Title Volvo Chassis - Windshield Wiper Function Inoperative In Intermittent Mode **ONLY**;  
Wiper Intermittent Setting Not Working - **Model Year 2018 to 2020**

**Volvo Model** VNL , VNR , VNX , VAH , VHD

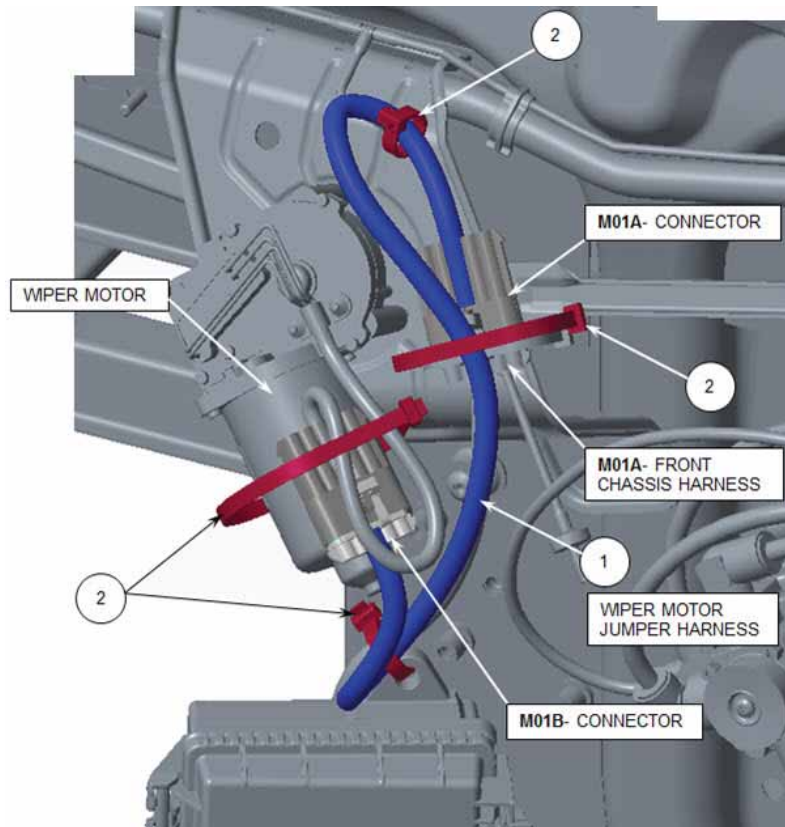
**Cause** For vehicles model year 2018 to 2020, the windshield wipers may not function when the intermittent setting is selected. This condition may result from wiper motor contact with the motor slip ring, resulting in the current from the Light Control Module (LCM) to the Wiper Motor to be too low.

**Solution** A partial containment will be for the installation of a jumper harness that contains a resistor to increase the current flow to the motor slip ring. Future containment will be a new cab harness that will be a new cab harness that will have the resistor integrated.

1. Order Harness Jumper 23522546.
2. Install the jumper harness as shown in the picture below.
